Access Compliance Report

Public Rights-of-Way

Intersection ID: 16413	Main Street: LANIER_AV	Cross Street: MONROE RD	Location: NE
ADA ID: DF7E8050B7AD	Ramp Type: PerpDiag	Initial Pass/Fail: Fail	Overall Compliance: No
Severity Score: 8.75			
Codes/Mitigation Info/Possible Solution		Field Measurements/Component Compliance

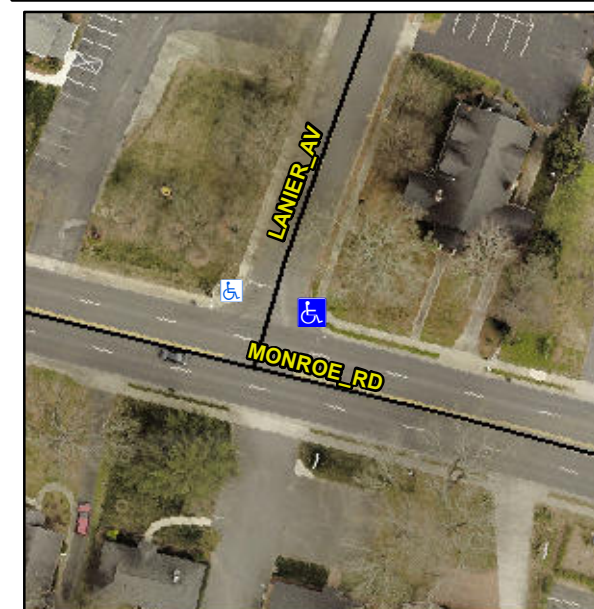
Not Found, R304.5.1

Compliance	Description	Data	Compliance	Description	Data
N/A	Ramp Length (in)	27.0	Yes	Ramp Slope (%)	5.1
No	Ramp Width (in)	44.0	Yes	Ramp XSlope (%)	1.0
N/A	Flare Type LT	N/A	N/A	Flare Type RT	N/A
N/A	Flare Slope LT (%)	N/A	N/A	Flare Slope RT (%)	N/A
N/A	Flare Traversable LT?	N/A	N/A	Flare Traversable RT?	N/A
N/A	Landing Length (in)	N/A	N/A	DWS Provided?	N/A
N/A	Landing Width (in)	N/A	N/A	DWS Contrast?	N/A
N/A	Landing Slope (%)	N/A	N/A	DWS Length (in)	N/A
N/A	Landing X Slope (%)	N/A	N/A	DWS Full Width?	N/A
N/A	Landing Curb? (Y/N)	N/A	N/A	DWS Offset (in)	N/A
N/A	Shared Landing?	N/A			
N/A	Gutter Ponding?	N/A	N/A	Gutter Slope (%)	N/A
N/A	Gutter Lip Ht (in)	N/A	N/A	Gutter X Slope (%)	N/A
N/A	Painted X Walk1?	No	N/A	Painted X Walk2?	No
	X Walk 1 Direction	To SW		X Walk 2 Direction	To SE
N/A	X Walk 1 Width (in)	N/A	N/A	X Walk 2 Width (in)	N/A
	X Walk 1 Slope (%)	2.1		X Walk 2 Slope (%)	0.2
	X Walk 1 X Slope (%)	1.0		X Walk 2 X Slope (%)	2.5

Remove & Replace Curb Ramp With Two New Directional Ramps or Equivalent.
